MFN 07-479  
September 4, 2007

Subject: **Submittal of ABWR Licensing Topical Report (LTR) NEDO-33372,  
"Advanced Boiling Water Reactor (ABWR) Containment Analysis"**

# Containment Analysis Input Parameters for ABWR

**Figure 3 Certified ABWR Feedwater Line Break Flow –  
Feedwater System Side of Break**

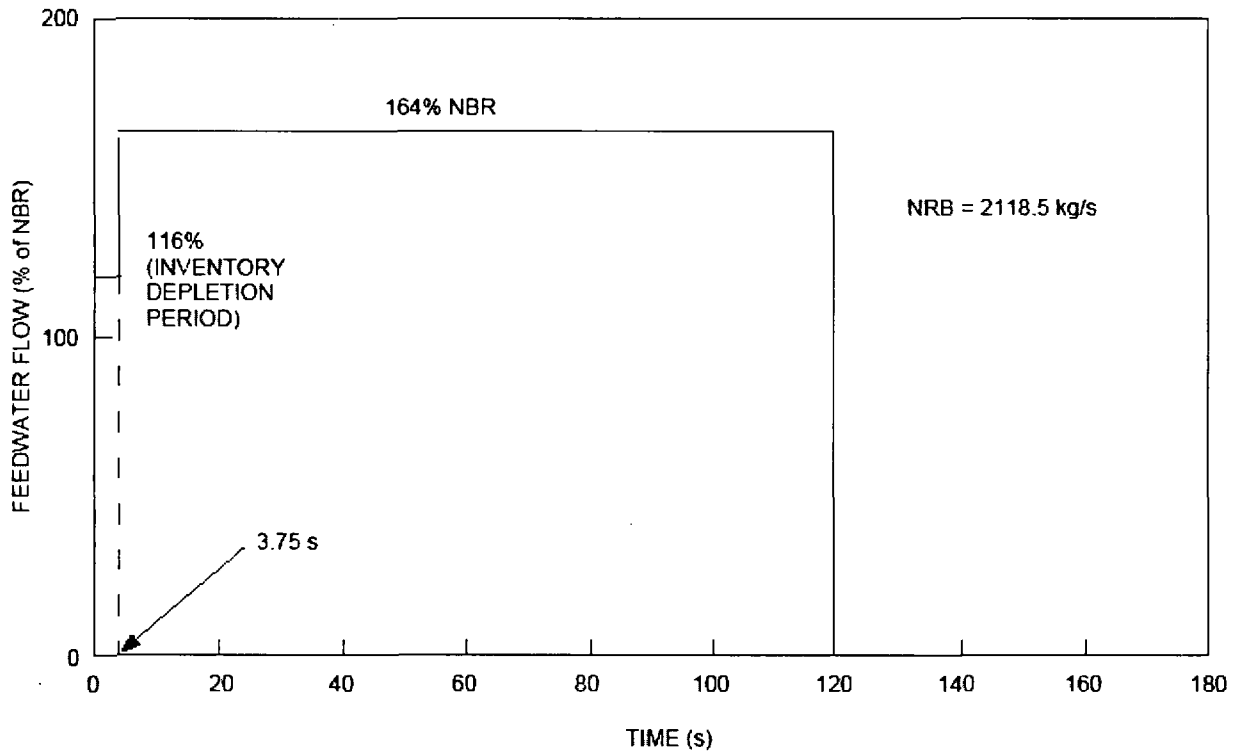
The feedwater system side of the FWLB was modeled (Figure 3) by use of a time variant feedwater mass flow rate and enthalpy directly to the drywell airspace. The time histories of the mass flow and enthalpy were determined from the operating characteristics of anticipated feedwater system performance.

The maximum possible feedwater flow rate was calculated to be 164% of nuclear boiler rated (NBR) flow, based on the response of the feedwater pumps to an instantaneous loss of discharge pressure. Since the Feedwater Control System would respond to the decreasing reactor pressure vessel (RPV) water level by demanding increased feedwater flow, and there was no FWLB logic/mitigation in the certified ABWR design, this maximum feedwater flow was assumed to continue for 120 seconds. This was based on the following assumptions:

**Figure 4 Revised Feedwater Line Break Flow –  
Feedwater System Side of Break**

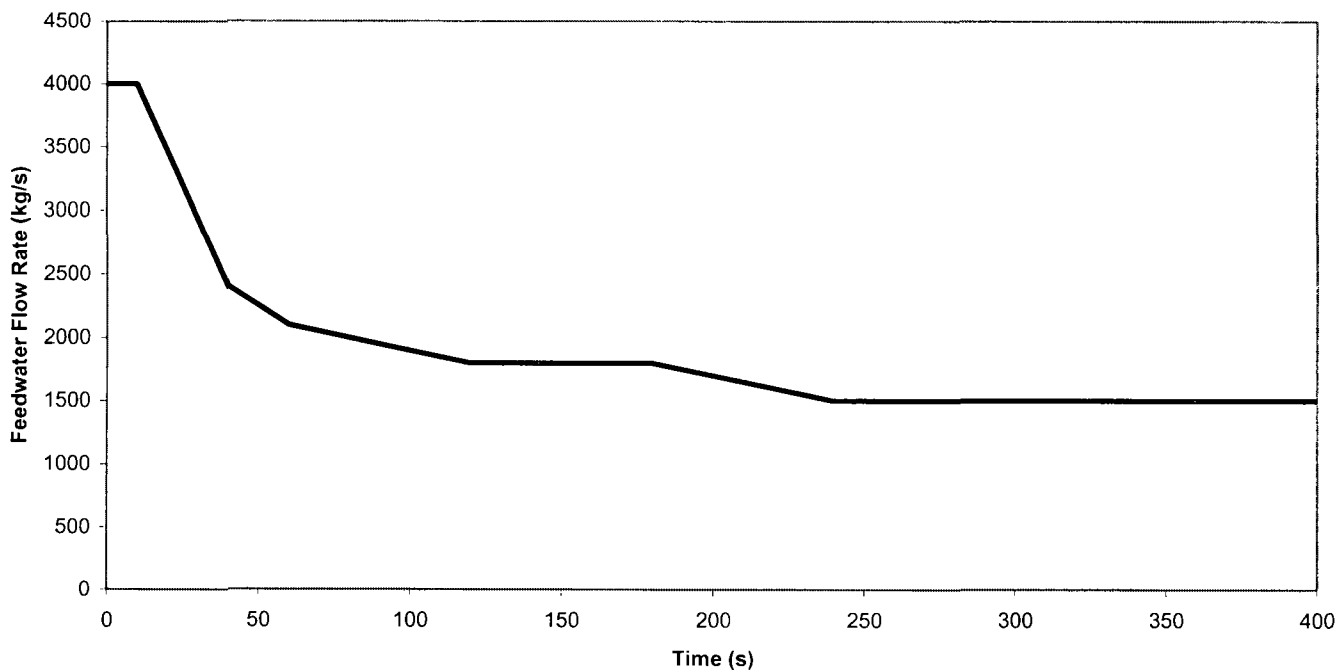
The feedwater system side of the FWLB was again modeled (Figure 4) by using a revised time variant feedwater mass flow rate and enthalpy directly to the drywell airspace. As shown in this figure, however, flow is assumed to continue until the condensate discharge and feedwater portions of the systems are drained. This eliminates the certified ABWR DCD baseline assumption of feedwater flow step changing to zero at 120 seconds. The time histories of the mass flow and enthalpy (Figure 5) were determined from the predicted characteristics of a typical feedwater system performance. The conservatism of the assumed mass flow and enthalpies will be confirmed after the detailed condensate and feedwater system designs and procurement of major equipment are completed (e.g., piping lengths and pump characteristics).

**Figure 6 Feedwater Line Break Mitigation**

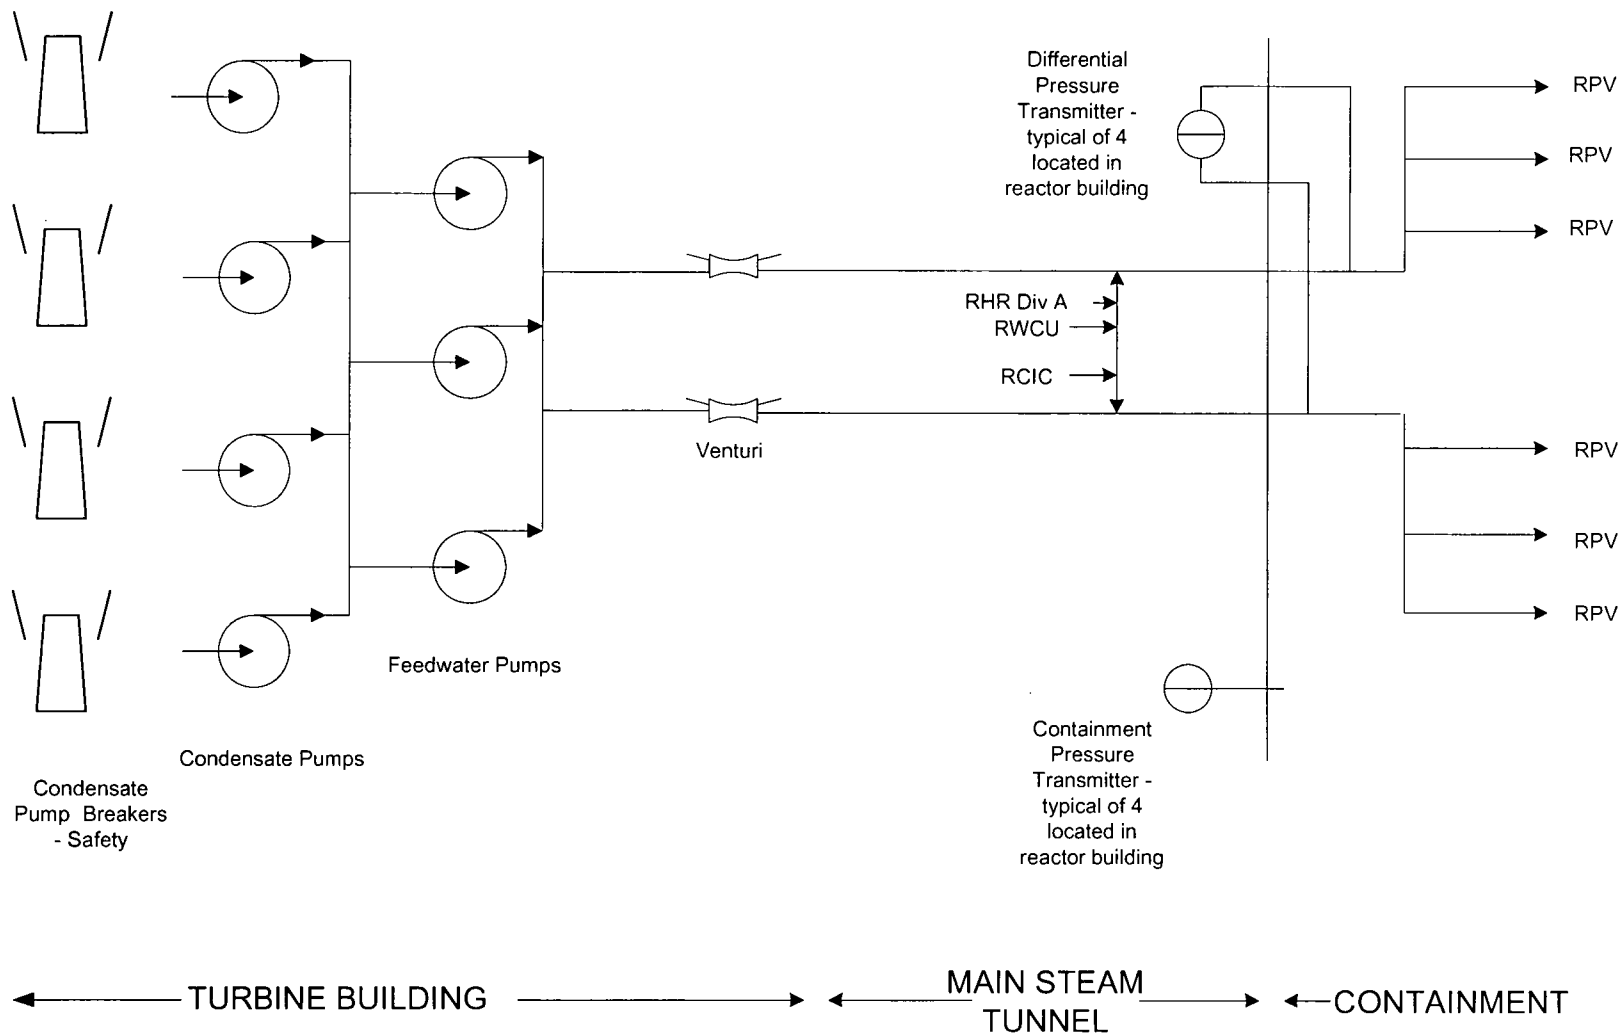
In addition, to provide added assurance of acceptable results, FWLB mitigation is added to the ABWR design. A break of the feedwater line is detected by instrumentation that measures the differential pressure between the two-feedwater lines and then confirmation of high drywell pressure will enable the logic to trip the condensate pumps (Figure 6). The logic and breakers will be safety-related to add assurance that only safety-related equipment is credited in the analysis.

**Figure 7 MSLB Short-term Temperature Response**

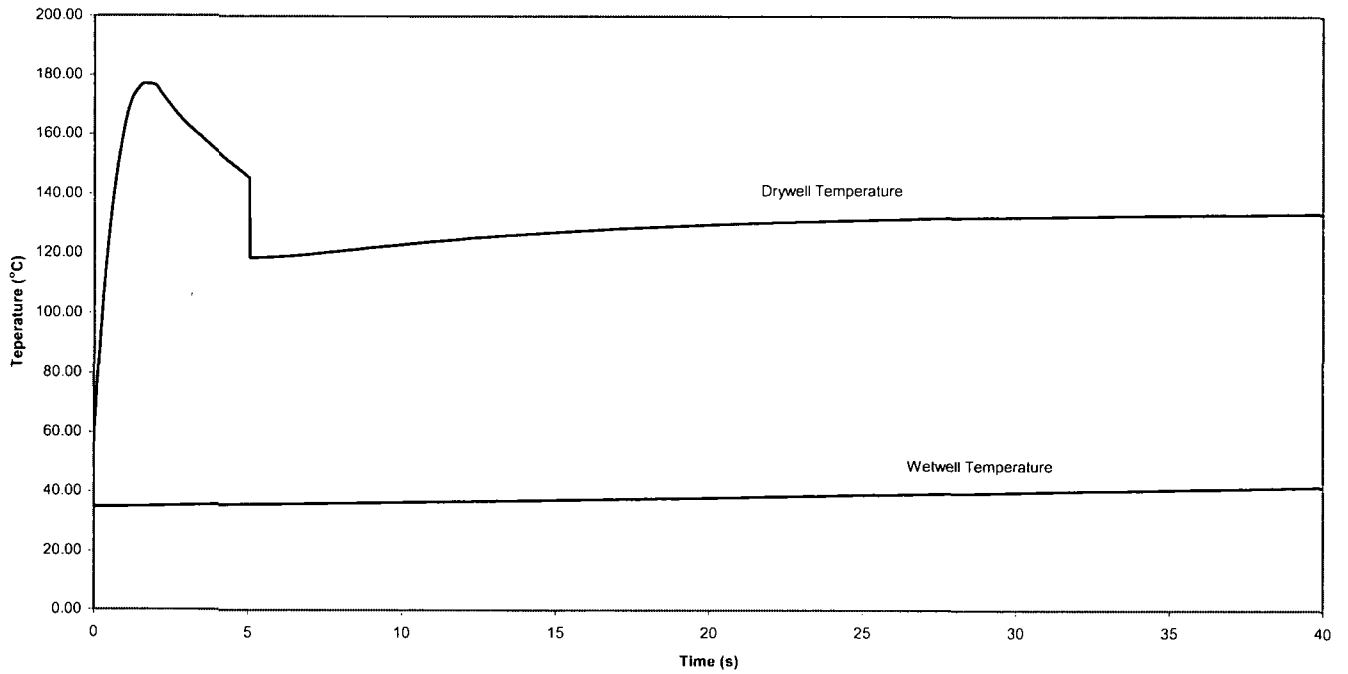
\* Design value is exceeded at 1.2 seconds into the event and then temperature decreases as shown in Figure 7.

Figure 3B-13 Schematic of the Pool Swell Phenomenon

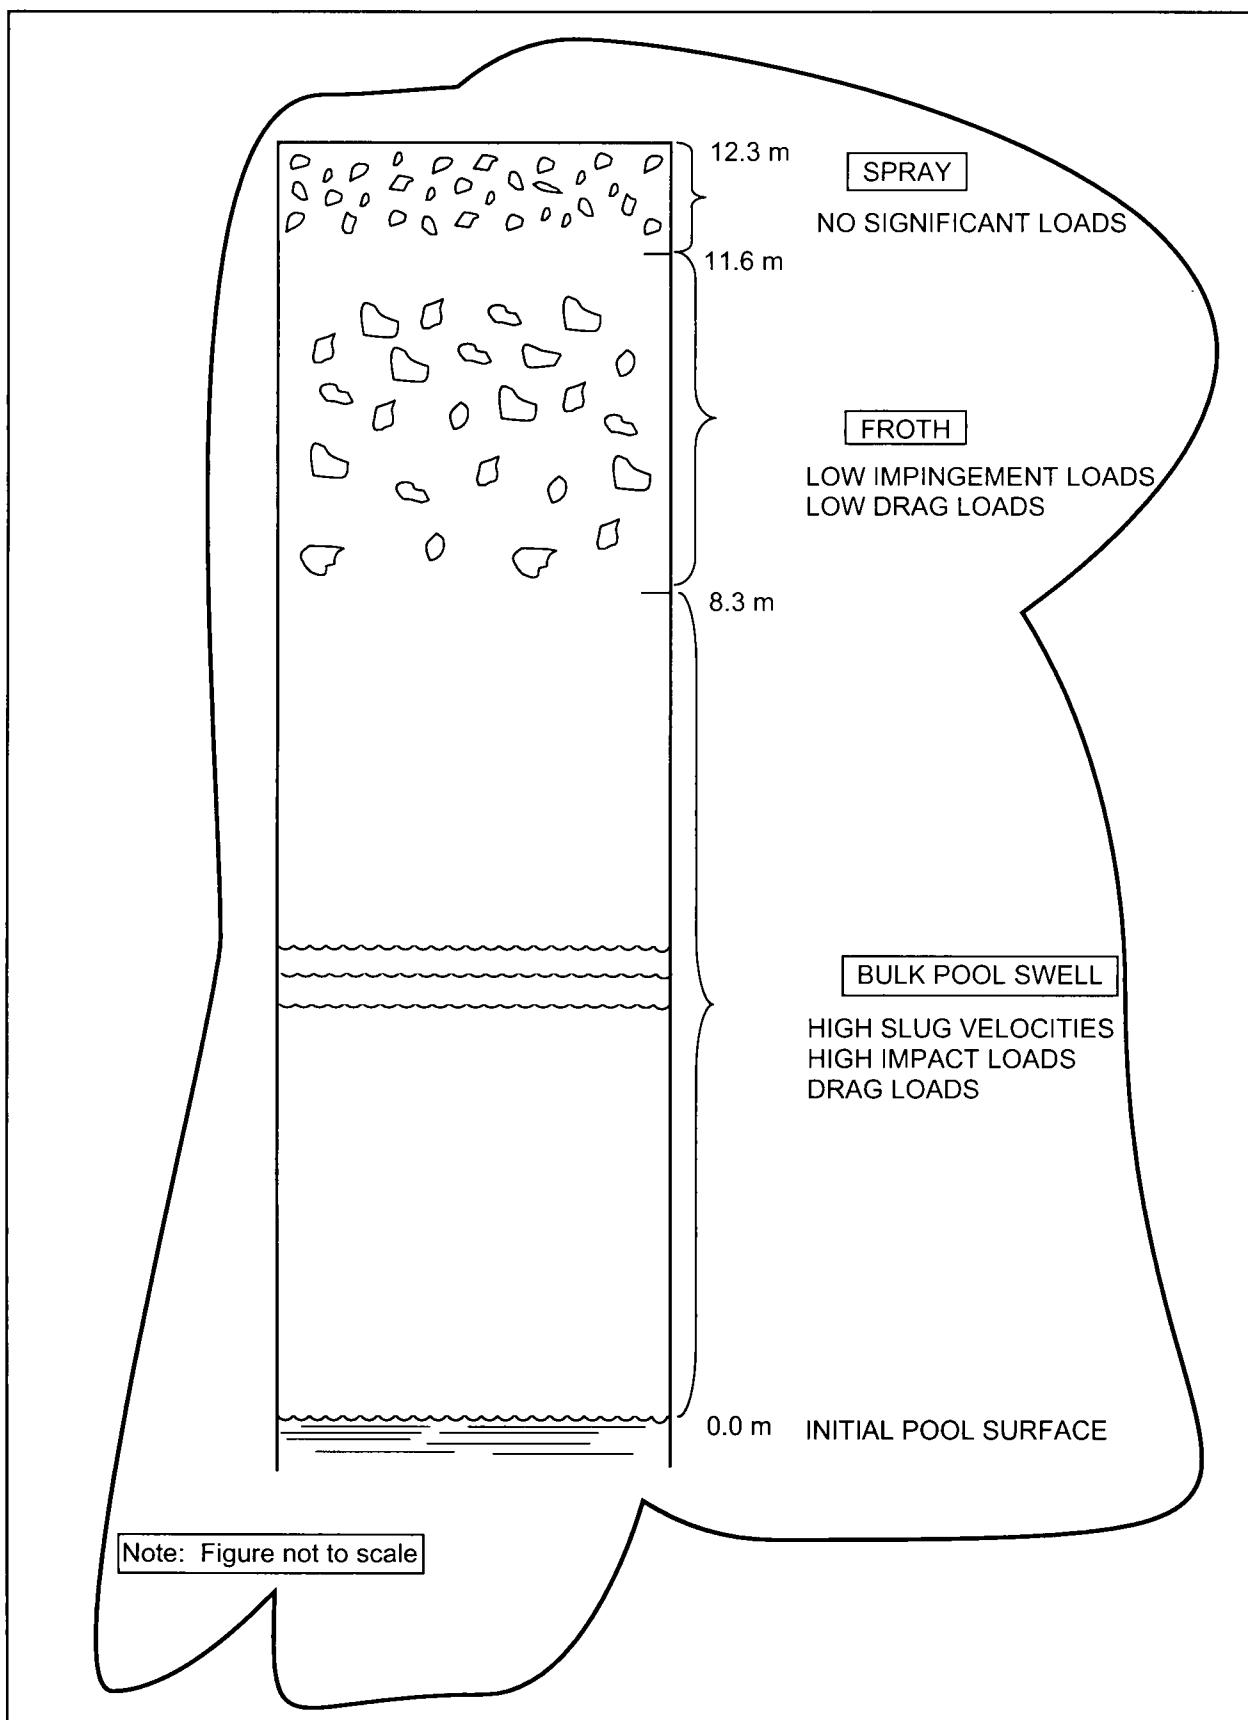
*As shown in Figure 3B-13 the gas space above the ~~10.3m~~ 11.6m elevation will be exposed to spray condition ~~including~~, which is expected to induce no significant loads on structures in that region.*

**Figure 6.2- 3 Feedwater Line Break Flow—Feedwater System Side of Break**

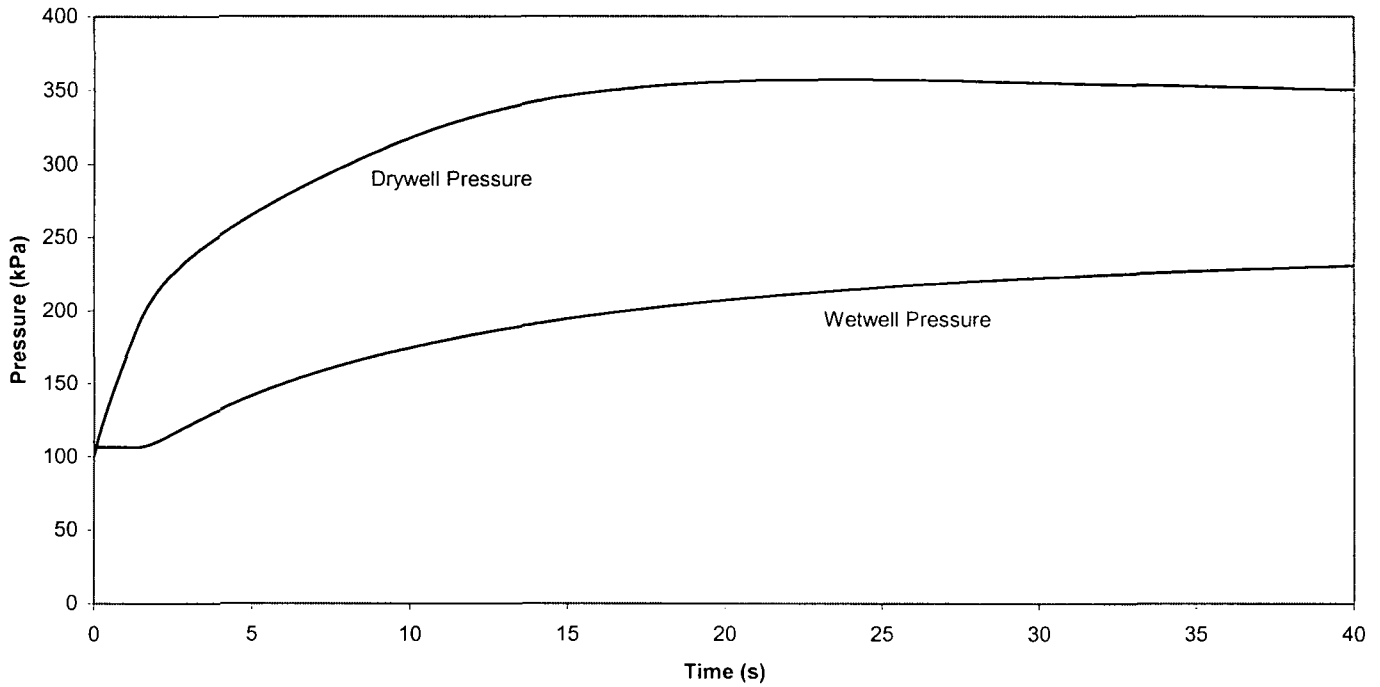
~~The maximum possible feedwater flow rate was calculated to be 164% of nuclear boiler-rated (NBR), based on the response of the feedwater pumps to an instantaneous loss of discharge pressure. Since the Feedwater Control System will respond to decreasing RPV water level by demanding increased feedwater flow, and there is no FWLB sensor in the design, this maximum feedwater flow was conservatively assumed to continue for 120 seconds (Figure 6.2-3). This is very conservative because:~~

**Figure 6.2- 8a Pressure Time History After a Feedwater Line Break**

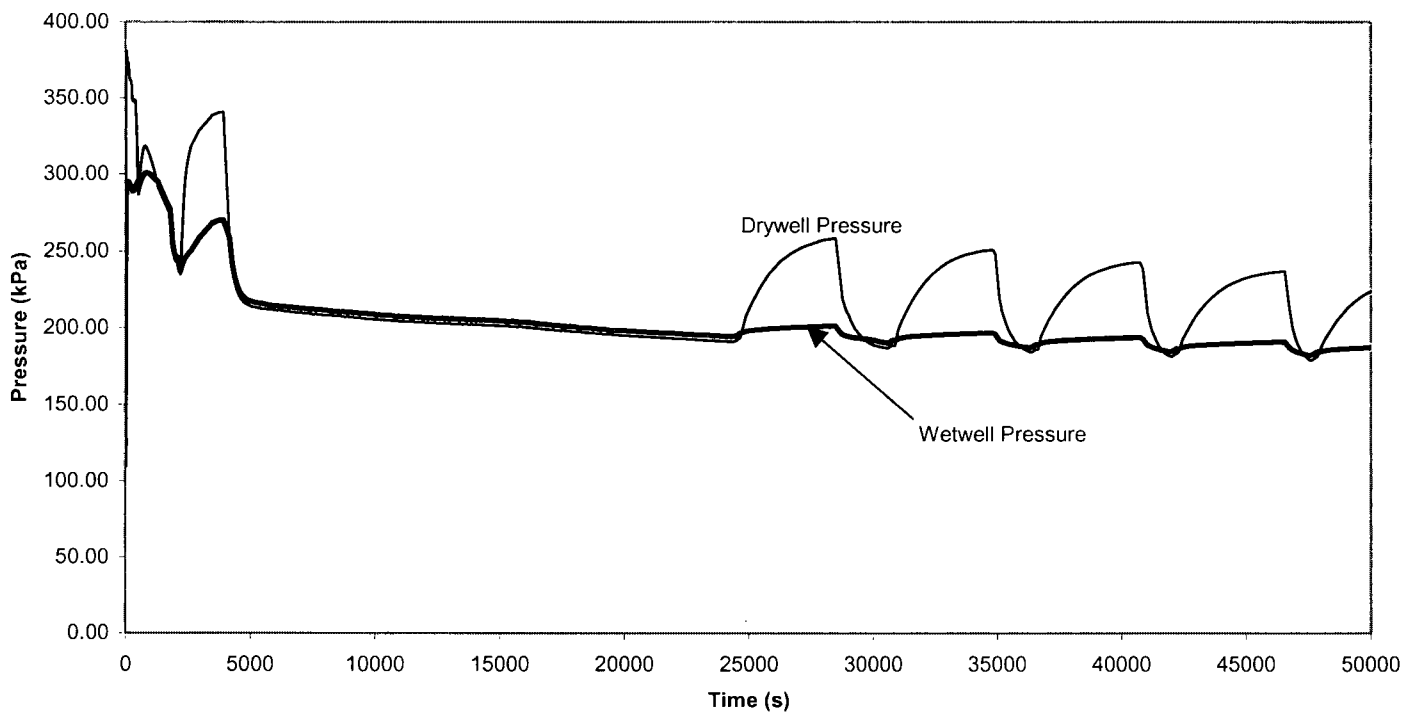
*The ~~short~~ long-term pressure peak (~~268.7~~ 279.6 kPaG) of Figure 6.2-8a is the peak pressure for the whole transient. Figure 6.2-8 shows temperature time histories for the suppression pool, wetwell, and drywell temperatures. The peak pool temperature (~~96.9~~ 97.1 °C) is reached at ~~15,350~~ 8596 seconds (~~4.264~~ 2.39 hours) and remains below the 97.2°C limit.*
